**DEVIATION REQUEST
AND DECISION FORM IN
ASSOCIATION WITH A
REQUEST FOR A PUD
MODIFICATION FROM
THE ECM**

Project Name : Urban Landing Preliminary Plan

Urban Landing

URBAN LANDING
PRELIMINARY PLAN
FIRE TRUCK ACCESS EXHIBIT

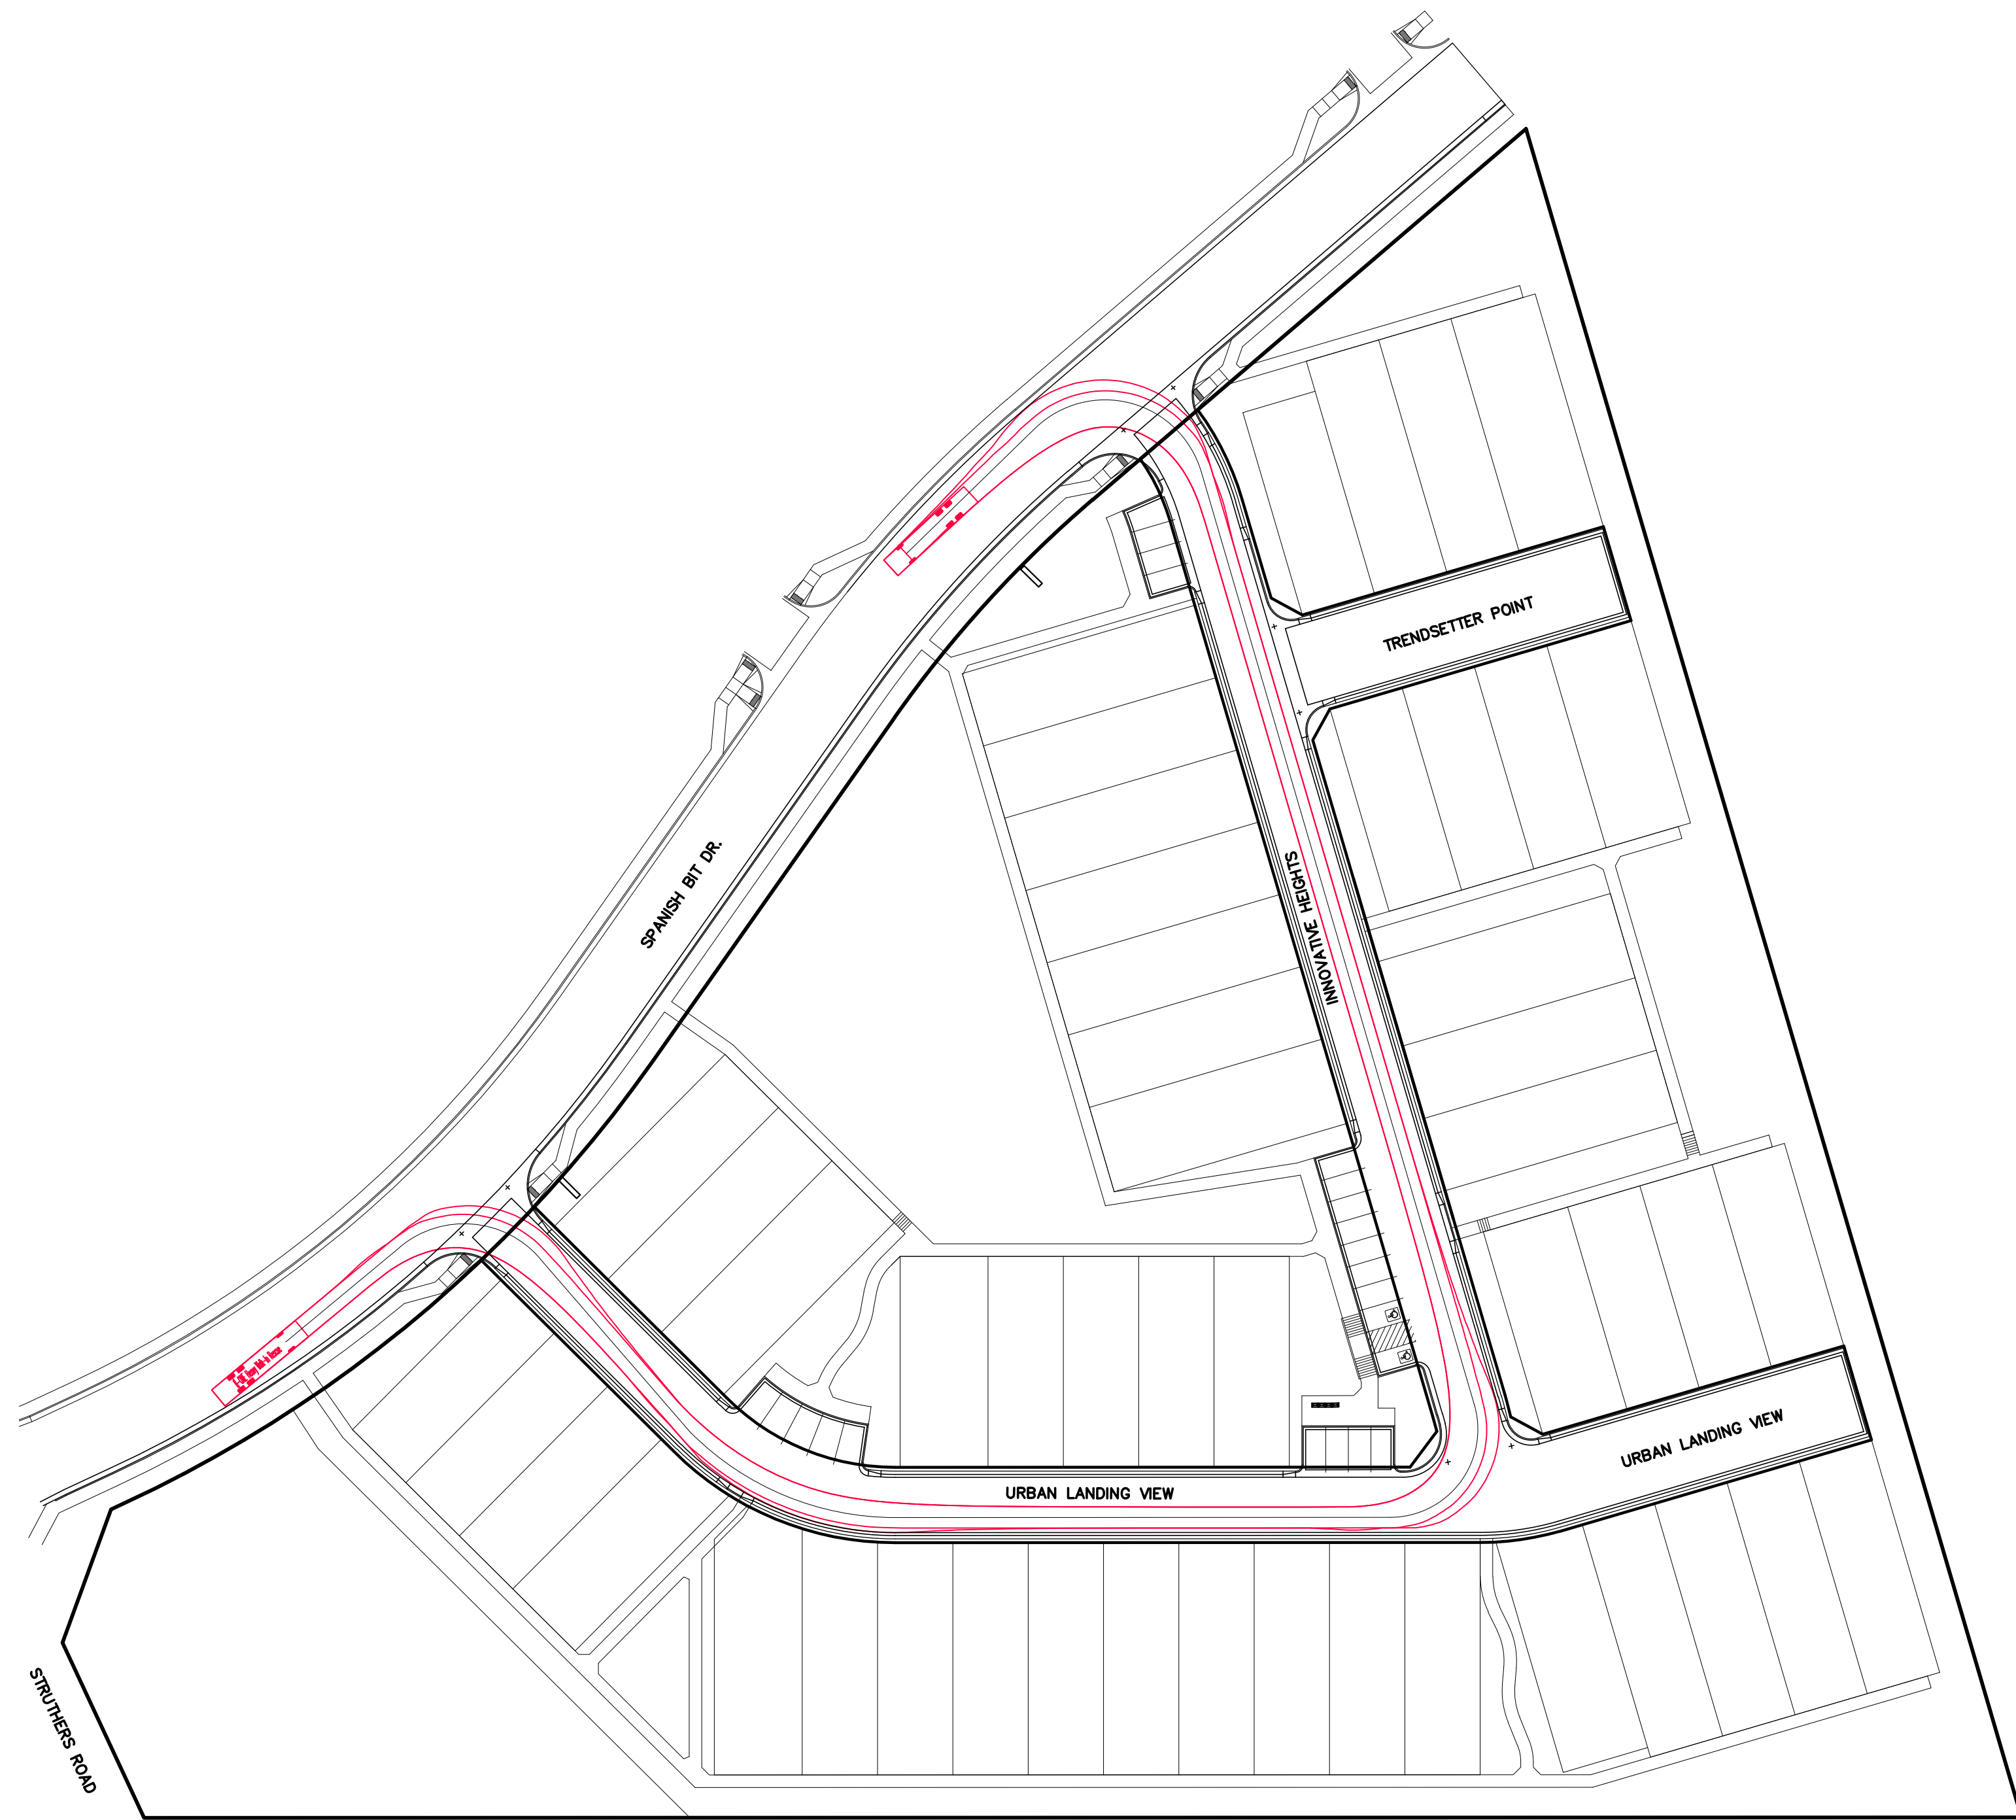
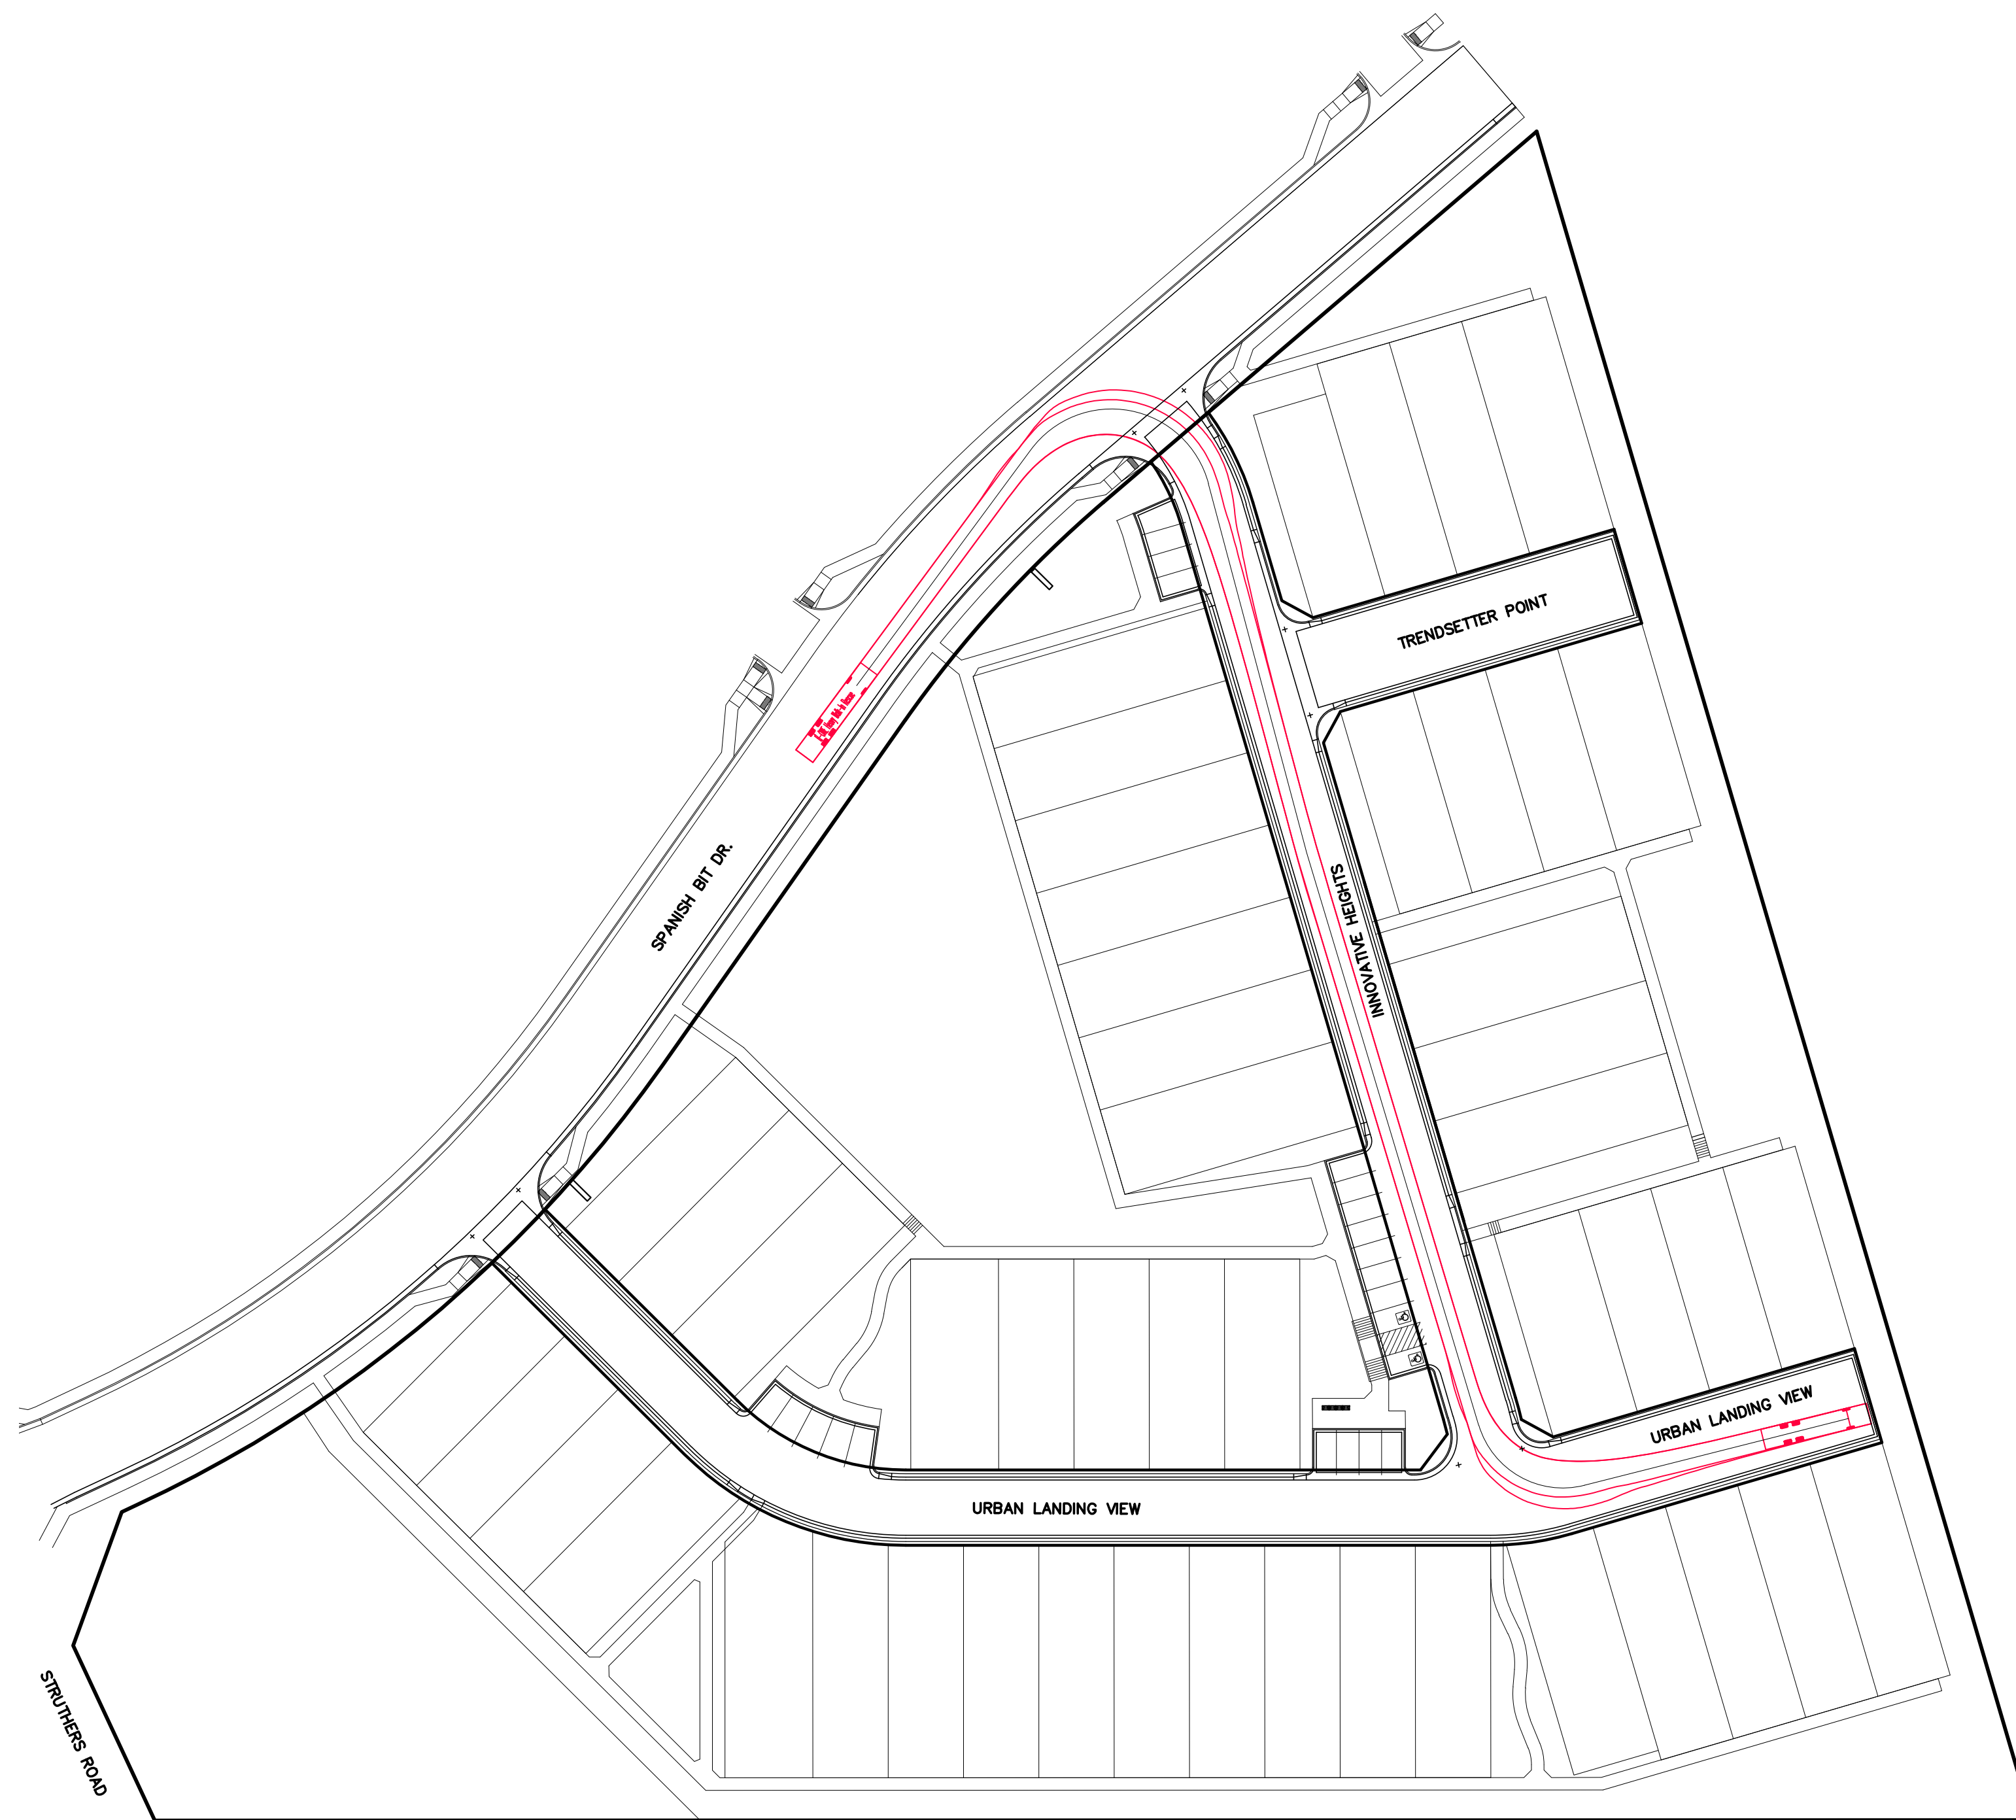
Awesome! Thanks again for the quick turn-around.
So you have no issues with the short dead-end roads?

No. They are short enough that it doesn't trigger a turnaround in the fire code.
